LOUISIANA
POWER & LIGHT

SUBJECT: Waterford 3 Steam Electric Station
Docket No. 50-382
Construction Adequacy of WSES-3 Basemat

On Thursday, March 22, 1984, your staff informally requested that LP&L be prepared to respond to a list of thirty-two questions at a meeting in Bethesda, Maryland on March 26, 1984. Extensive efforts of key project personnel resulted in the preparation of draft responses to the questions, which were handed out at the March 26, 1984 meeting. However, as was indicated by our representatives at the meeting, due to the extent of the questions and the volume of our response, coupled with the extremely short response time (four days, including the weekend), we were not able to subject the responses to a thorough review prior to the meeting.

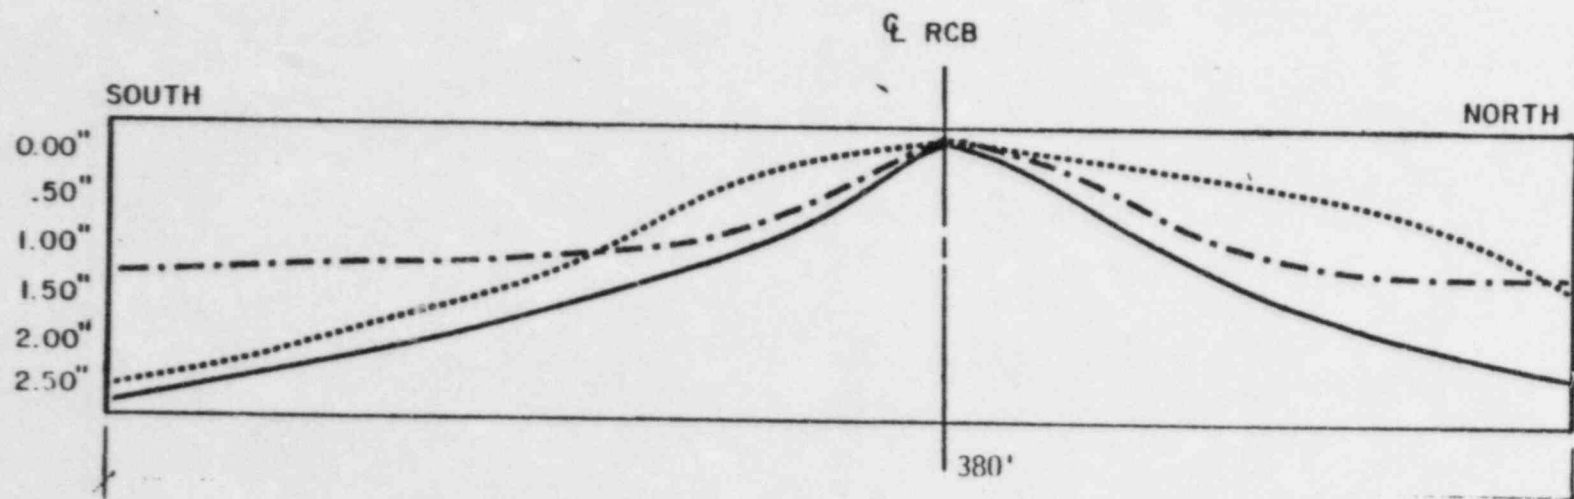
Response:

Attached is a graph (Figure ES-3) reflecting the contours obtained from the maps generated on April 22, 1977, November 10, 1977, and October 9, 1979. These curves reflect a before mat (ring wall) loading, after ring wall placement and a majority of concrete construction complete. These contours do reflect a convex mat with maximum differential of two inches (2").

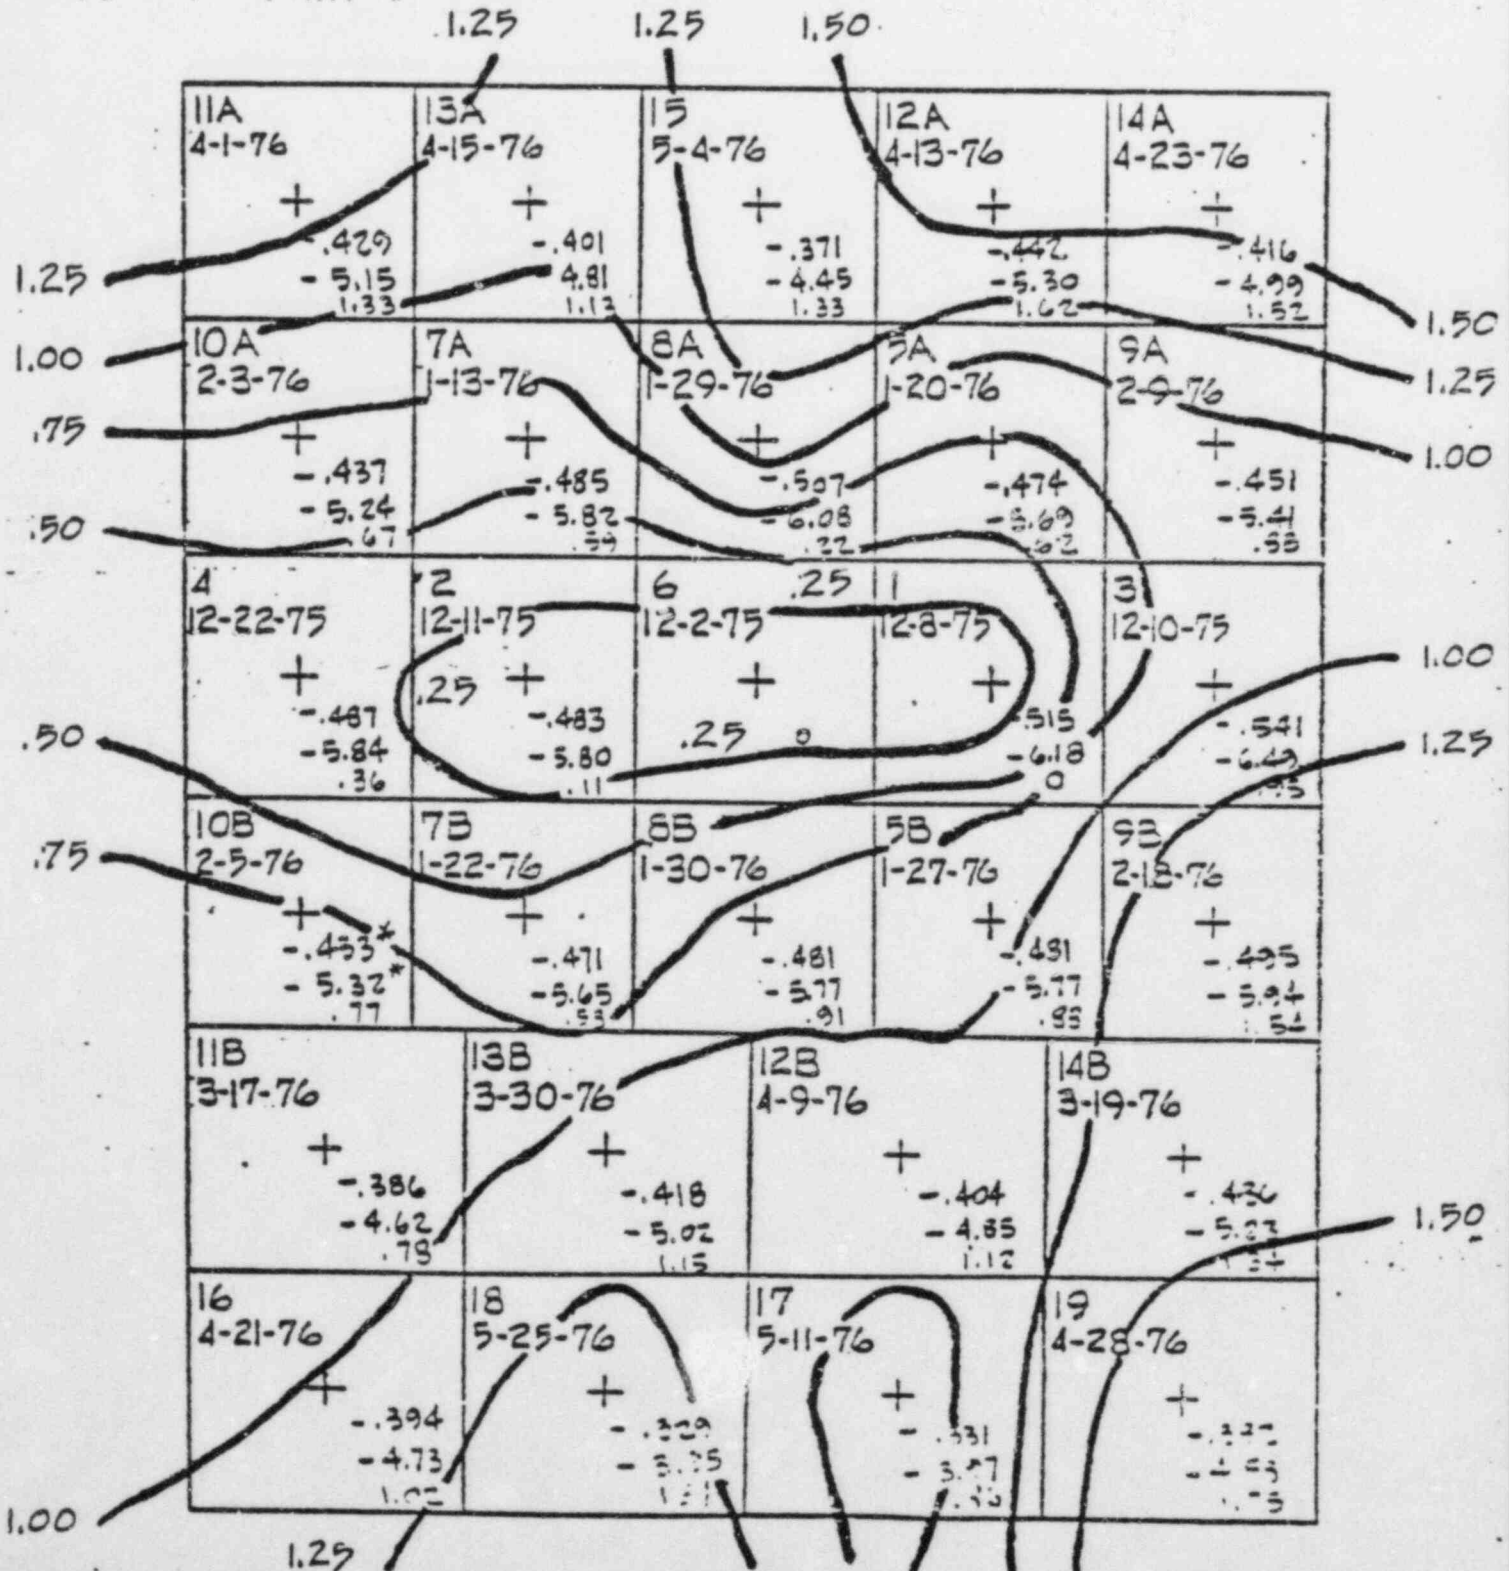
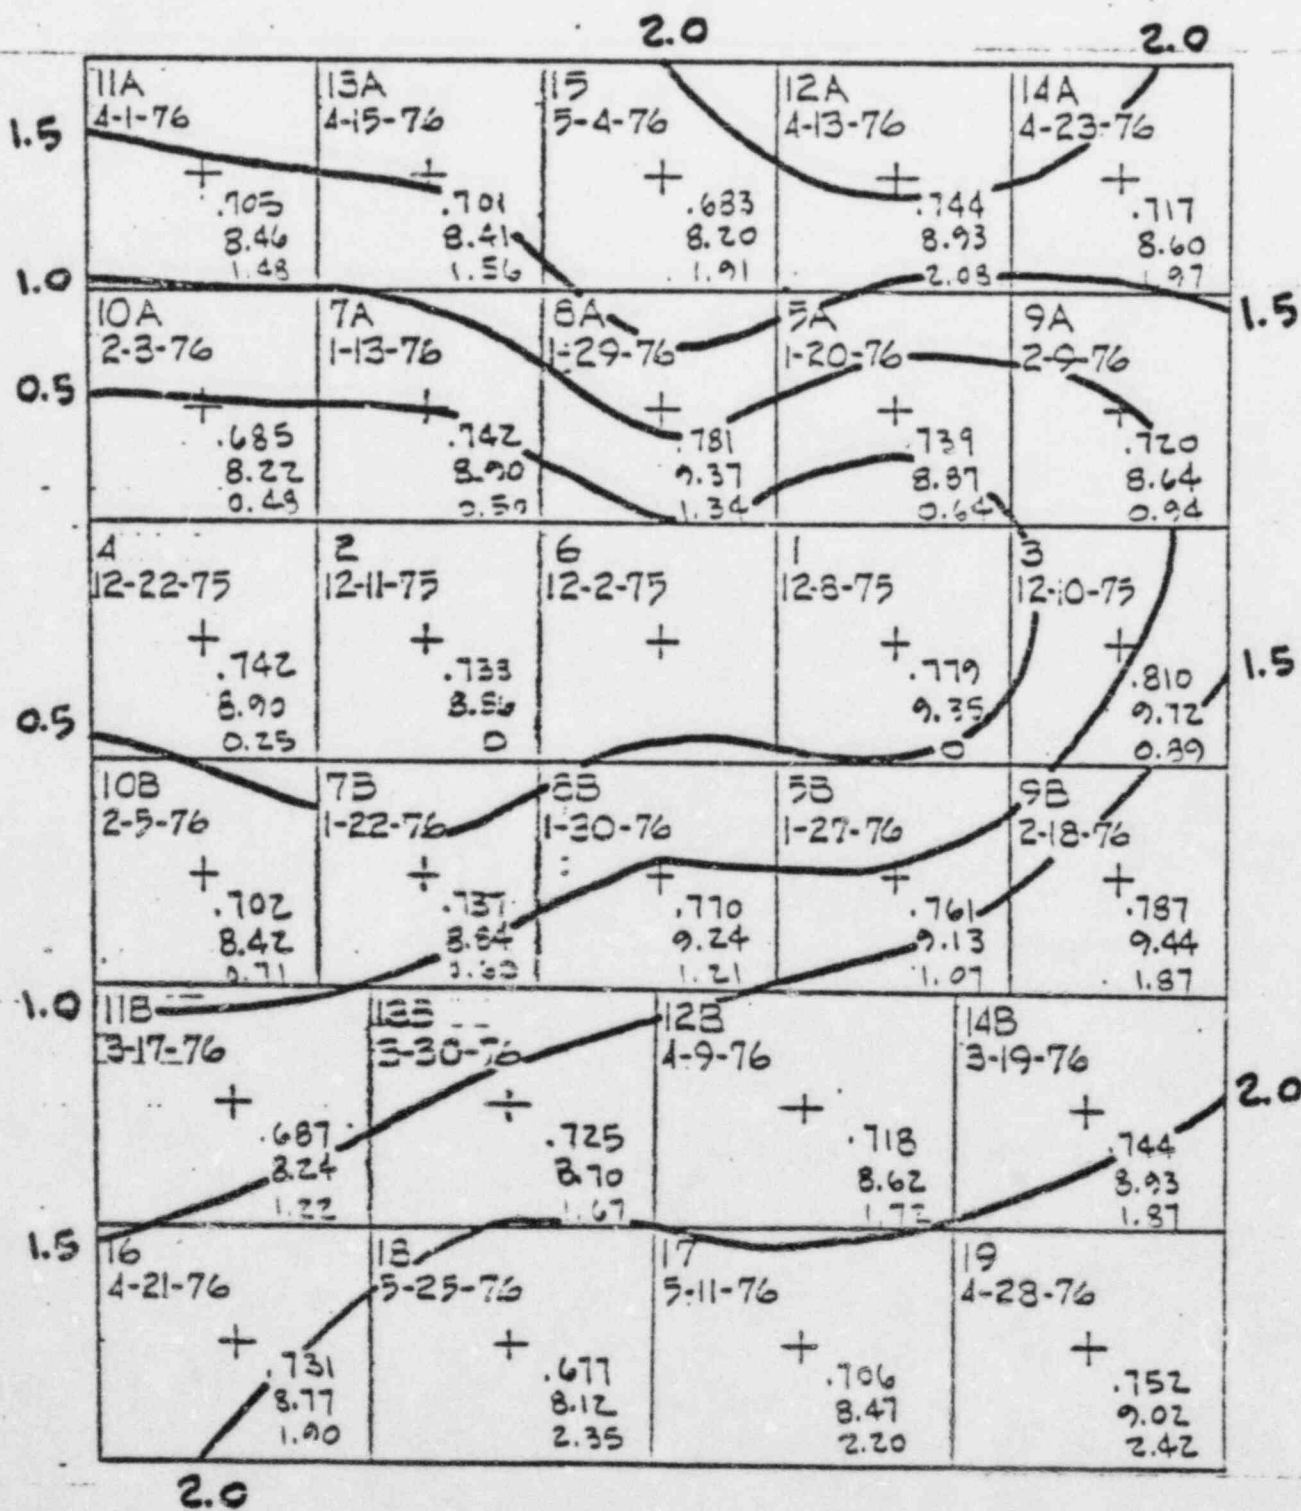
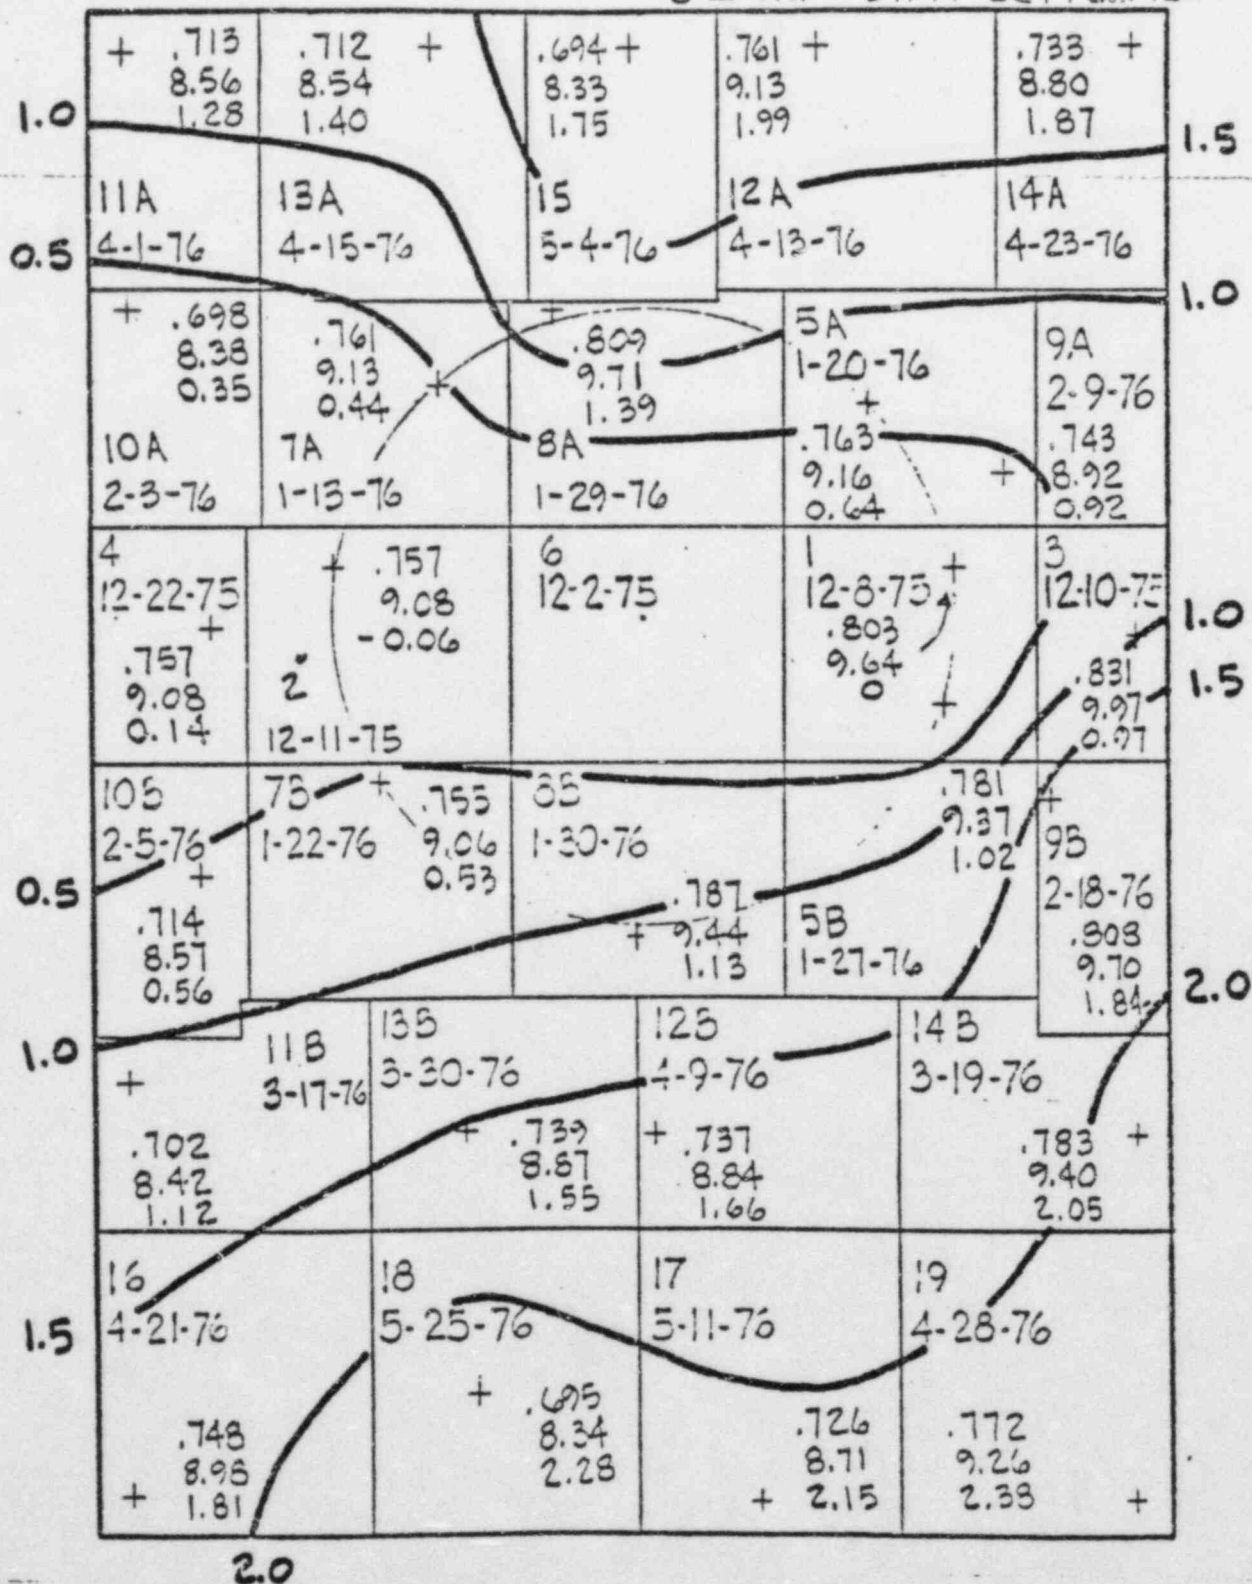
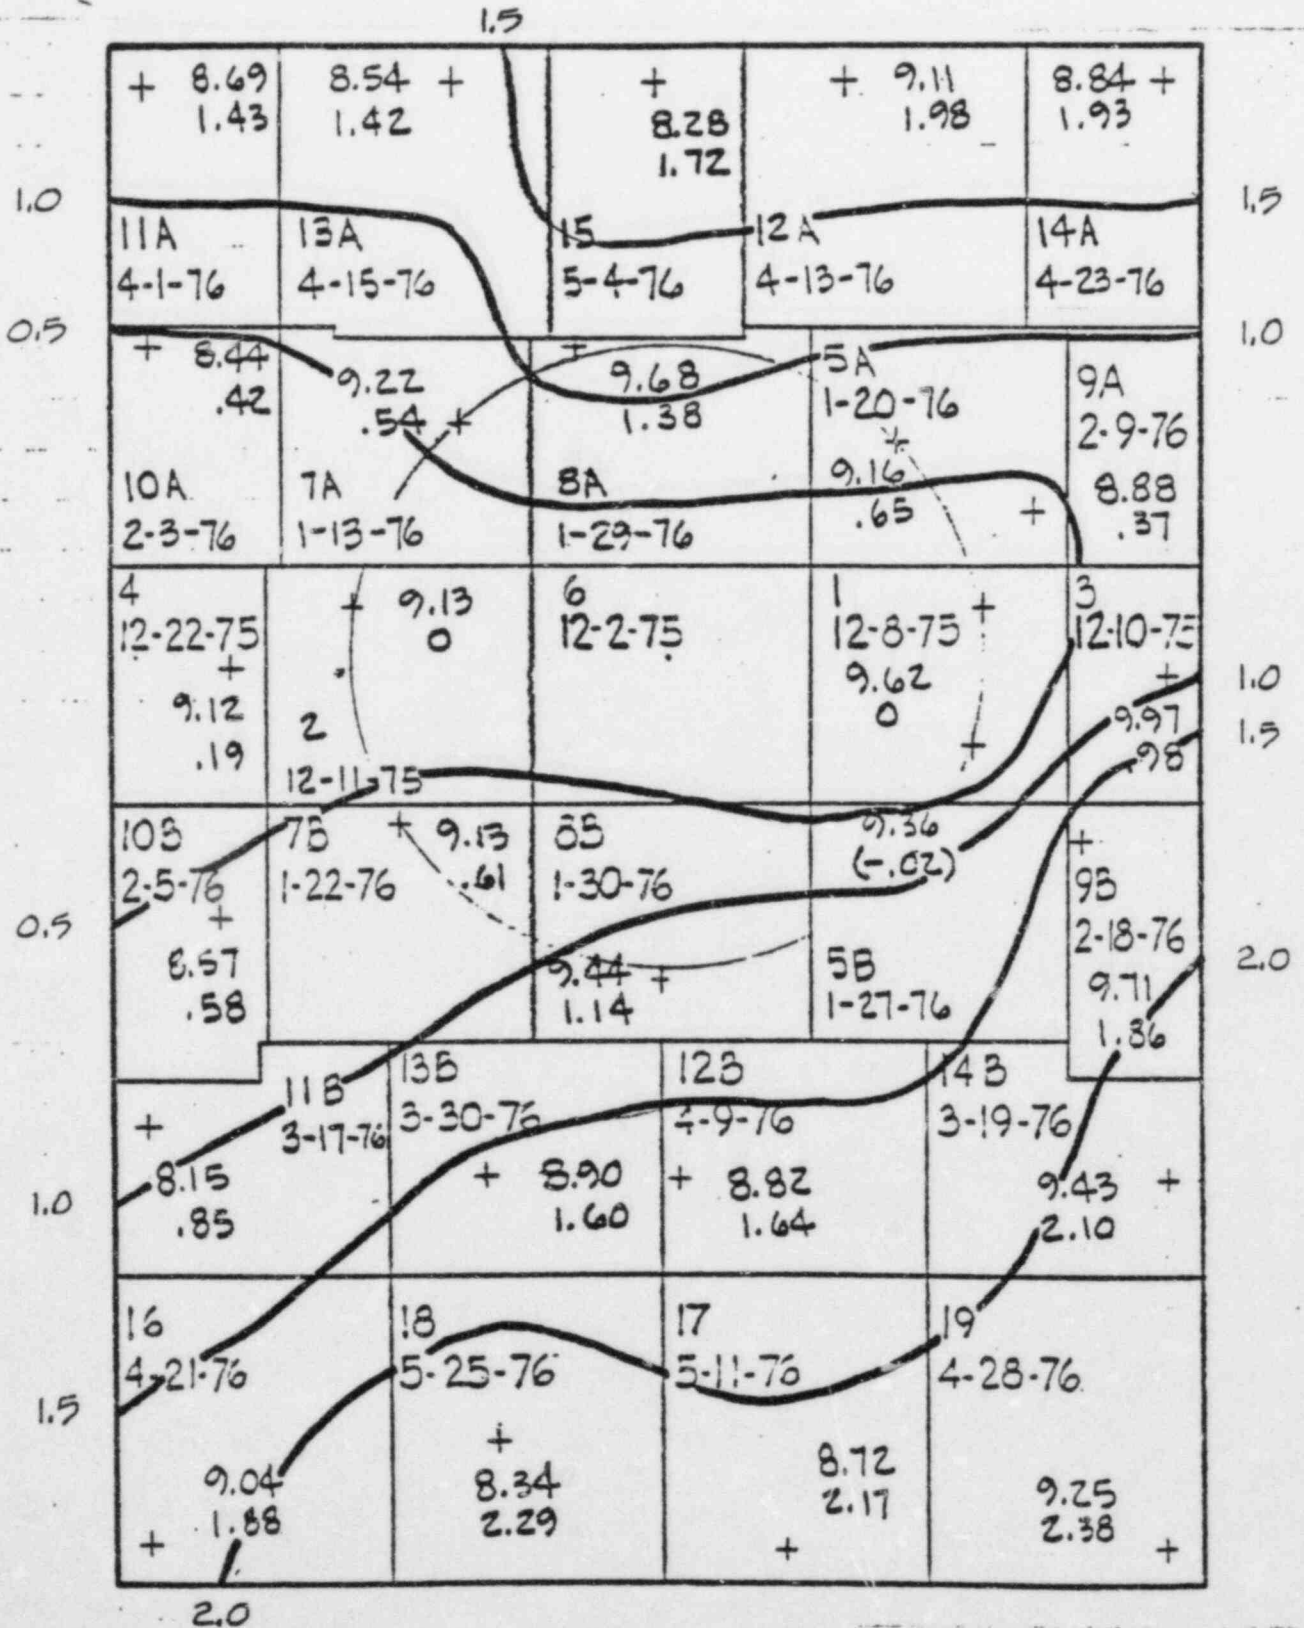
17. Provide differential settlement contours for 6 month periods, starting from early 1977 to present.

Response:
